**STAFF REPORT TO AMADOR COUNTY AIRPORT LAND USE COMMISSION
FOR MEETING OF TUESDAY, NOVEMBER 14, 2017**

ITEM NO. 1 - Review and possible compatibility determination relative to the proposed Tanner Backwash Recycling Project which proposes the installation of two 35' high steel tanks and associated pumping and piping facilities for the purpose of recycling treatment plant backwash wastewater.

**Subject: Airport Land Use Commission Application
Amador Water Agency
Tanner Backwash Recycling Project**

| | | PRELIMINARY PROFILE FIGURE 3 | |

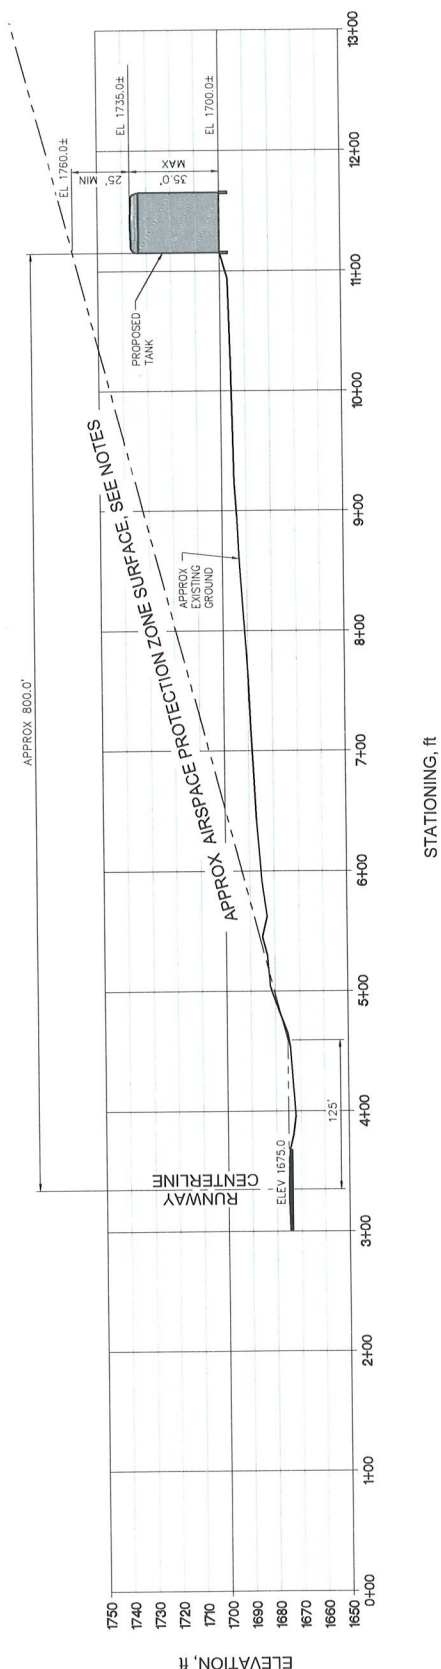
1. The proposed project consisting of 2 enclosed tanks with a metal roofing system does not constitute a wildlife hazard attractant;
2. The proposed 35' high tanks will be at a maximum elevation of approximately 1735' msl which is approximately 55' AFE (above field elevation) and which does not penetrate the imaginary surfaces maximum height limit for the project site; and
3. The proposed project consisting of two 35' high tanks with a pump station and associated piping system for the Amador Water Agency Tanner Backwash Recycling Project is a compatible land use (Utilities) for Overflight Zone 3 of the 1990 ALUCP and Safety Zones 3 and 6 of the proposed 2017 ALUCP Update, subject to the above two findings.

4. Obtain FAA approval of Notice of Proposed Construction or Alteration pursuant to 14 CFR Part 77.
5. Construction of project shall be substantially the same as proposed. Any substantial change will require resubmittal to the ALUC.
